# City of Santa Barbara California

## PLANNING COMMISSION STAFF REPORT

**REPORT DATE:** January 3, 2007  
**AGENDA DATE:** January 10, 2007  
**PROJECT ADDRESS:** 3230 State Street (MST2006-00574)

SITE NAME:	MAYTAR
SITE NUMBER:	SV010200
SITE TYPE:	ROOF TOP ANTENNA INSTALLATION
LOCATION:	3230 STATE ST., SANTA BARBARA, CA 93103 COUNTY OF SANTA BARBARA
APPLIC. TYPE:	ENLARGED SITE PLAN & ANTENNA LAYOUT
DATE:	
SHEET NUMBER:

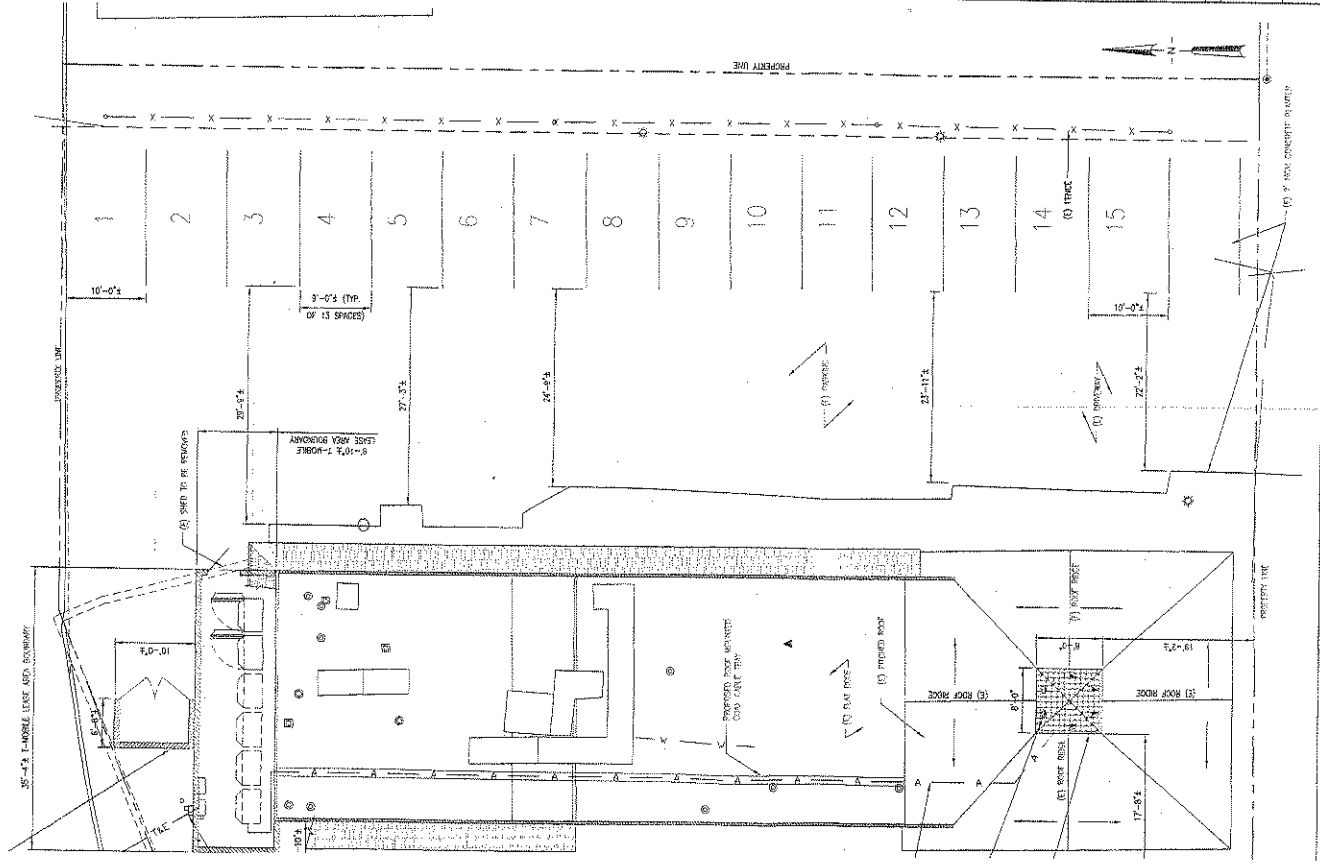
- 1) The Board is concerned with the cupola as designed, and looks for renovation and redesign of the cupola to make it match architecturally more into the style of the existing building with the suggestion of not using a hip-roof.

- 3) The Board is concerned with the height of the tower as shown on the plans, and is looking for solutions to mitigate the overall height of the tower.

- 5) The Board suggests utilizing louvers or other types of elements which may animate the cupola tower when completed.
- 6) Applicant to show all the cupola tower plans and revise the site plan to show the accurate parking and driveway layout.

8) The rear equipment closure area is acceptable as redesigned, as it is no longer against the property line in the back allowing for a mature canopy skyline tree to be placed along the property line at the street and other landscaping needs to be shown on the plans.

9) The trash closure location is acceptable as shown, with the applicant to complete the required curb and driveway changes as indicated on plans.
